Product / Process Change Notification (PCN)		
PCN #:	PCN_WCAP-PSLC_20210421	Change Category:
Affected Series:	WCAP-PSLC	□ Equipment / Location☑ General Data□ Material
PCN Date:	January 21, 2022	☐ Process
Effective Date:	April 21, 2022	□ Product Design□ Shipping / Packaging□ Supplier□ Software
Contact:	Product Management	Data Sheet Change:
Phone:	+49 (0) 7942 - 945 5001	⊠ Yes □ No
Fax:	+49 (0) 7942 - 945 5179	Attachment:
E-Mail:	pcn.eisos@we-online.com	□ Yes ⊠ No
DESCRIPTION AND PURPOSE OF CHANGE:		
Because of a database mismatch, Würth Elektronik will update all datasheets for the matchcode WCAP-

Datasheet Update

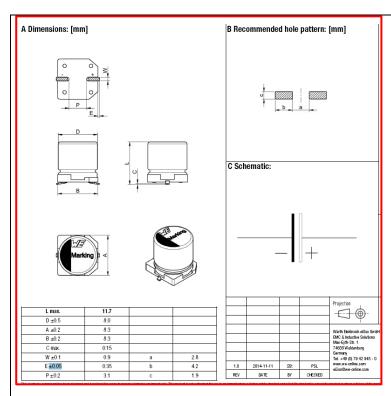
Würth Elektronik will update the datasheet layout in general for all WCAP-PSLC datasheets. Furthermore with this layout update Würth Elektronik will correct the electrical and mechanical characteristics. All corrections in terms of electrical characteristics are shown below. They will also be clearly visible in the new datasheets which Würth Elektronik will provide on the website shortly.
